GOVERNMENT AIRCRAFT FACTORIES

In Reply Quote S/B NMD-32-10
Revision 1
16th October, 1981

SUBJECT: NOMAD SERVICE BULLETIN NMD-32-10 REVISION 1

SUBJECT: ELIMINATION OF OPENINGS IN NOSE LANDING GEAR ACTUATING MECHANISM HOUSING (MODIFICATION N345)

Installation of Mod N345
Figure 1

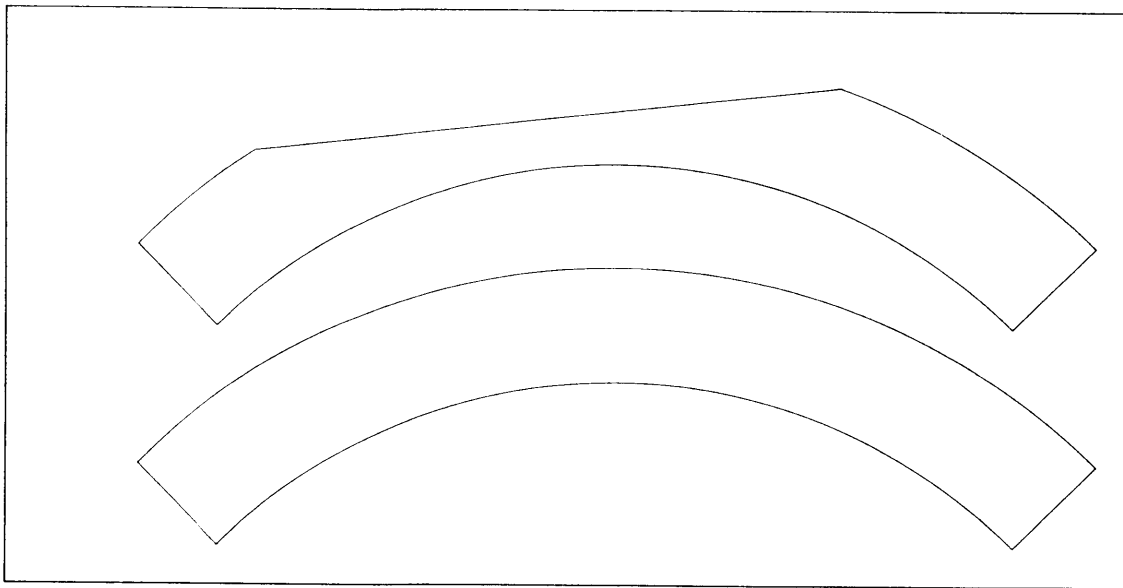
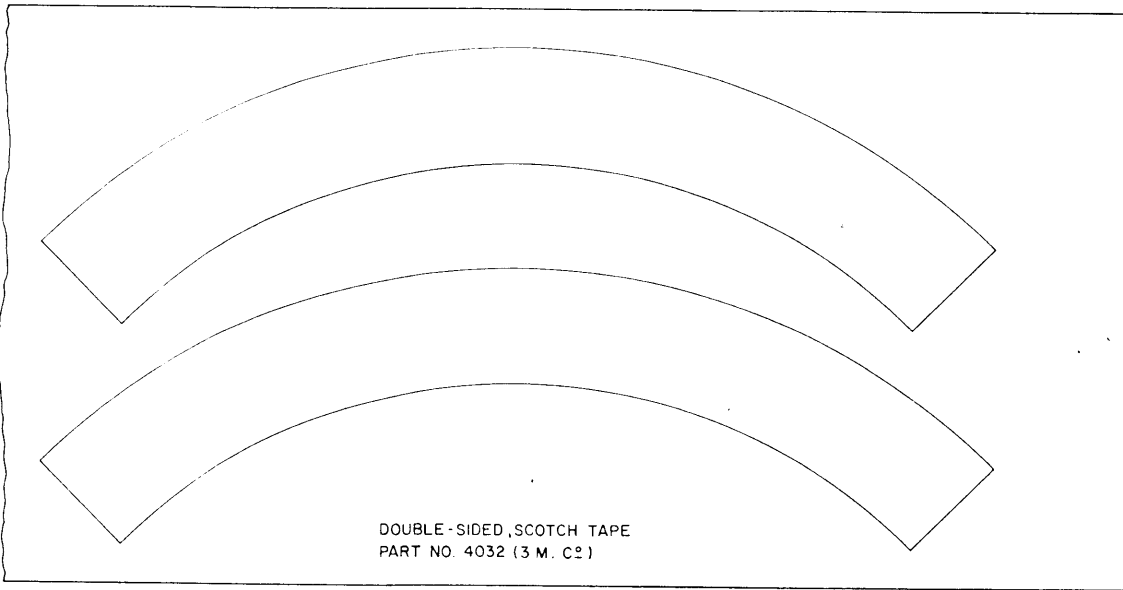
- C. Fit blanking plate P/N 1/N-10-1227 over five inch diameter lightening hole in left hand side panel of the centre console (Ref Figure 1).
- (1) Thoroughly clean mating surfaces with a degreasing solvent such as trichlorethylene.
 - (2) Secure blanking plate to left hand side panel using double-sided Scotch tape P/N 4032 (3M Co.) cut as illustrated in Figure 2.
- D. Remove nose gear screw actuator chain drive cover assembly, discard upper chain cover and four self-locking nuts and retain lower chain cover, side cover plate and the remaining attaching parts (Ref Figure 3).

G. Install seal P/N 1/N-40-933 between the screw actuator and the wheel well top panel (Ref Figure 1).

(2) Make an angled cut through the seal (Ref Figure 1).

(1) Locate angle P/N 1/N-40-929 in position against upper chain cover (Ref Figure 1) and drill 0.1285 inch diameter hole in wheel well top panel to suit.

Chain Drive Cover Assembly Installation
Figure 3

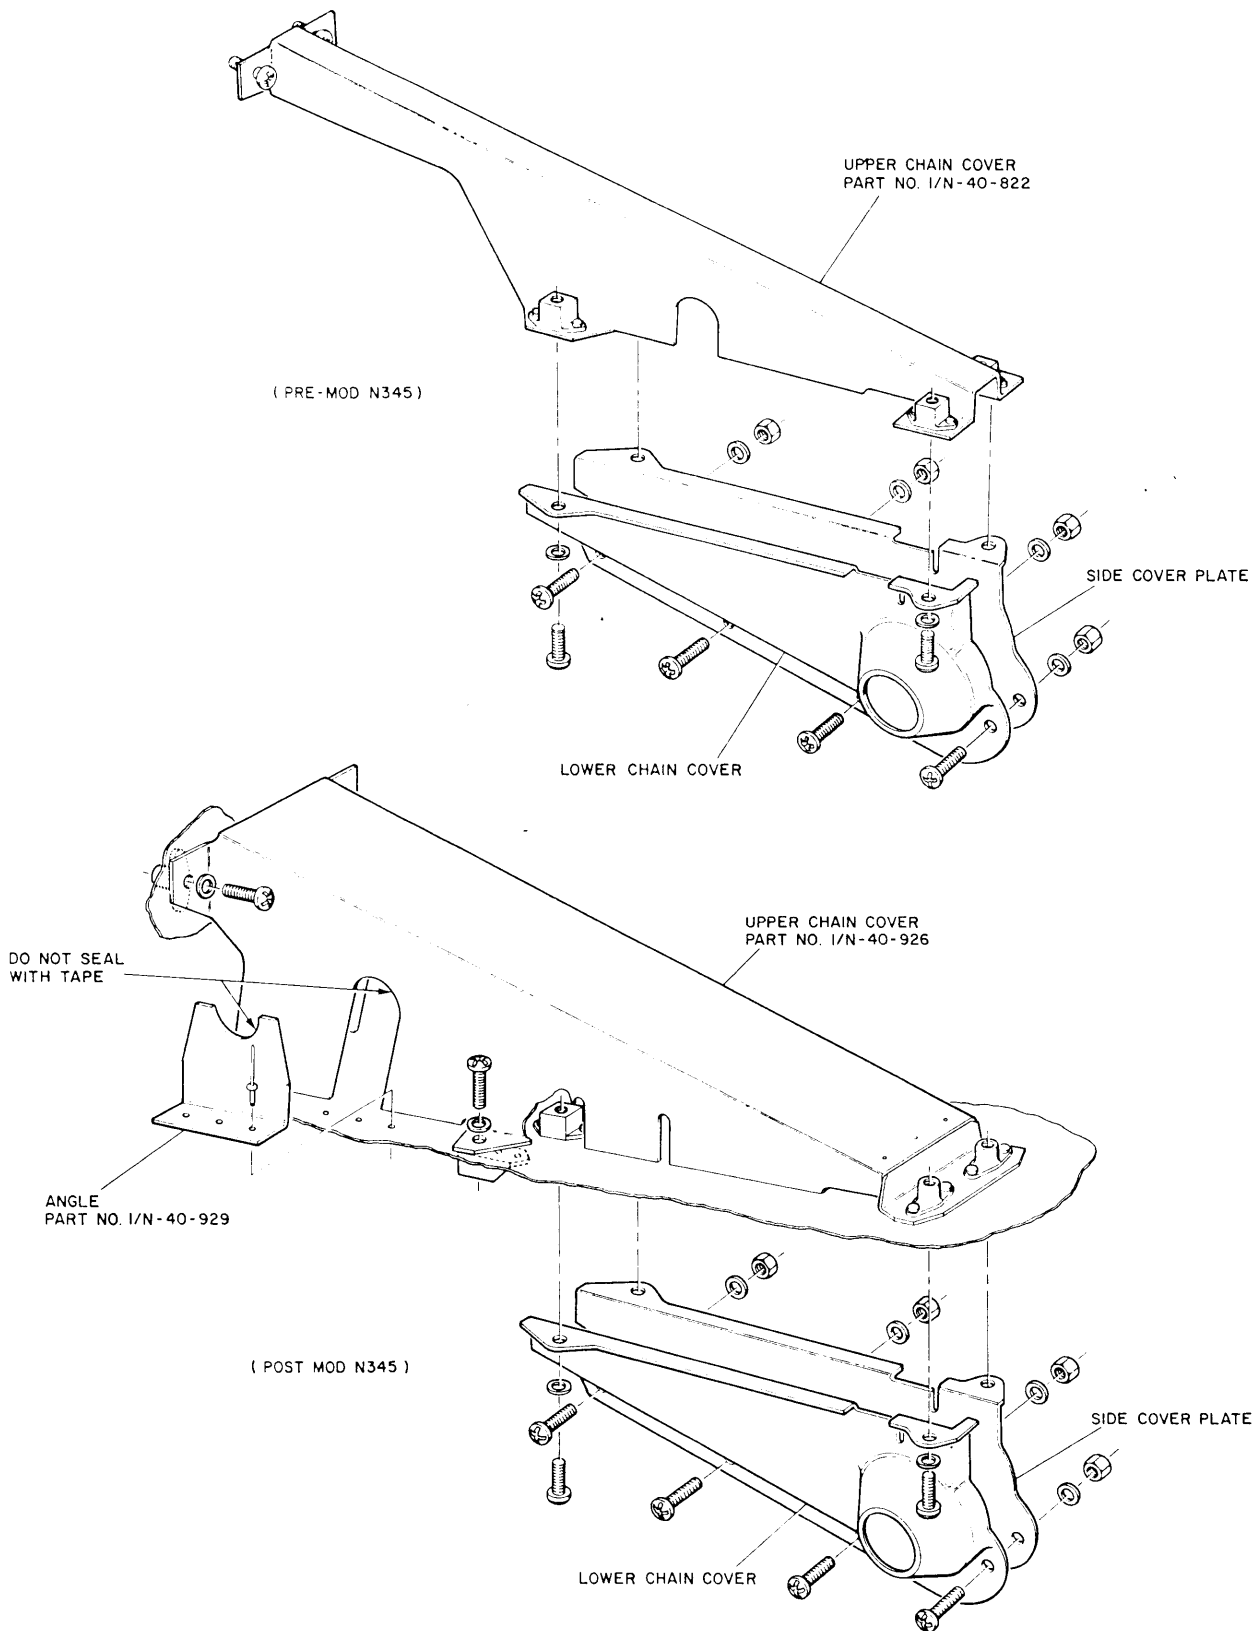
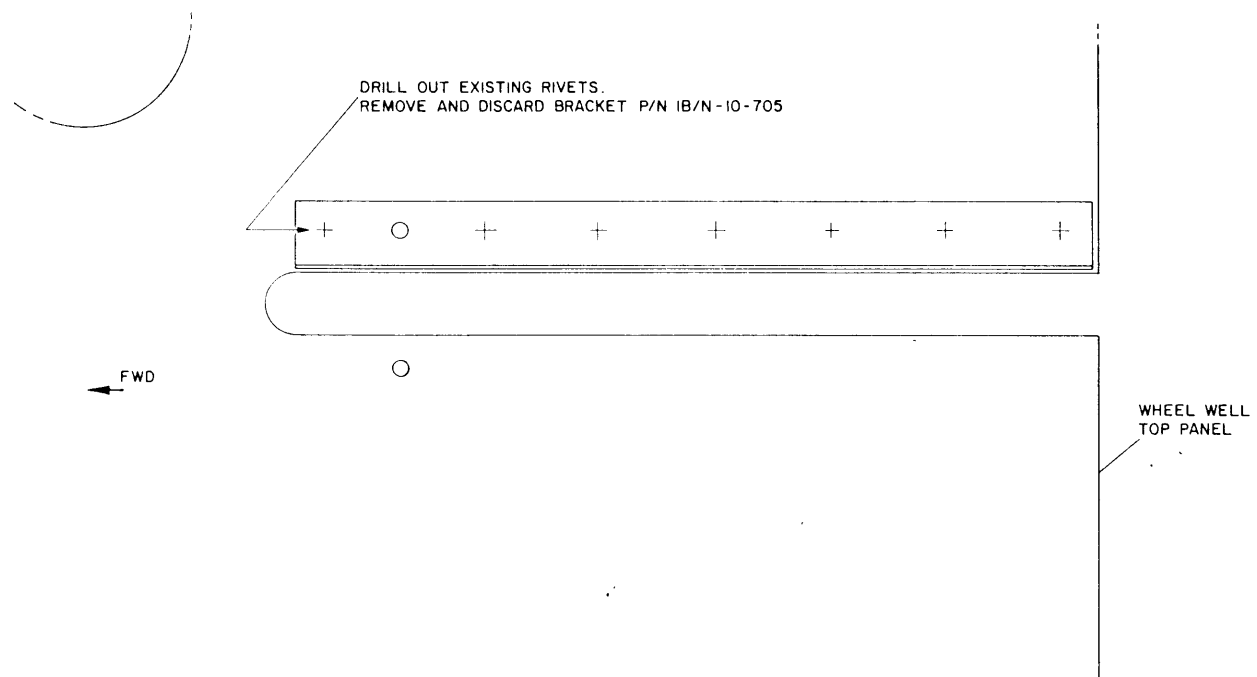
J. Fit new upper chain cover P/N 1/N-40-926 using attaching parts, screws P/N MS35207-262 and washers AN960PD10 (Ref Figure 3).

L. Refit lower half of the chain cover and side cover plate, with a fillet of Silastic RTV731 between mating surfaces, using the four self-locking nuts P/N MS21044N3 and the attaching parts retained in Para 2D (Ref Figure 3).

N. Seal all edges and gaps that provide direct access to the chain with adhesive backed tape such as BEAR No. 383, 1 inch wide, except where indicated on Figure 3.

Removal of Bracket P/N IB/N-10-705
Figure 4

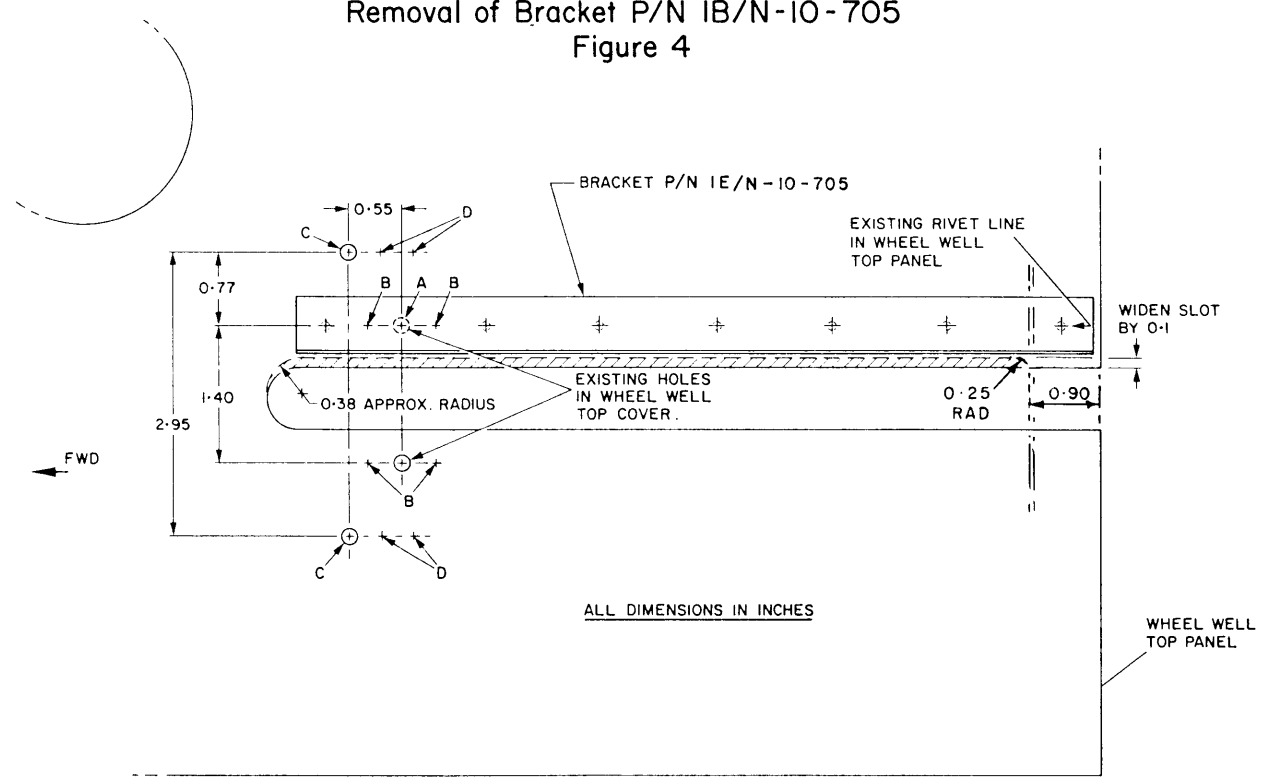
- E. Rework wheel well top panel.
- (1) Remove and discard bracket P/N 1B/N-10-705 (Ref Figure 4).
 - (2) Widen the slot in the wheel well top panel by carefully cutting off 0.1 inch of metal along the RH side of the slot (Ref Figure 5).

Rework of Diaphragm
Figure 6

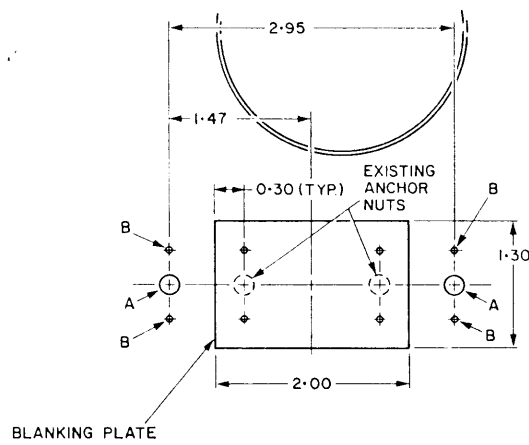
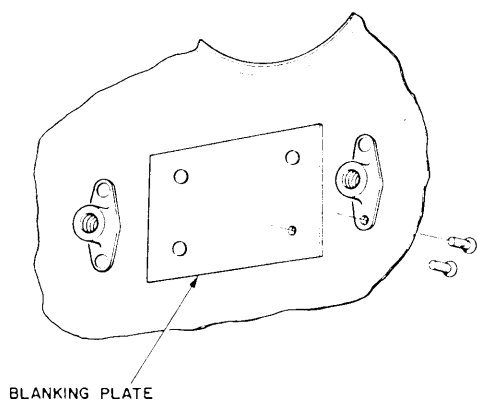
F. Rework diaphragm (Ref Figure 6).

(1) Drill out rivets retaining existing anchor nuts and discard the anchor nuts (Ref Figure 6).

(2) Manufacture blanking plate (Ref Figure 6) and rivet to diaphragm using suitable rivets.

(3) Drill two 0.202 inch diameter holes (A on Figure 6).

(4) Align anchor nut P/N MS21047-L3K with each hole A, then drill four 0.096 inch diameter holes (B on Figure 6) using the anchor nut as a template. Dimple forward.
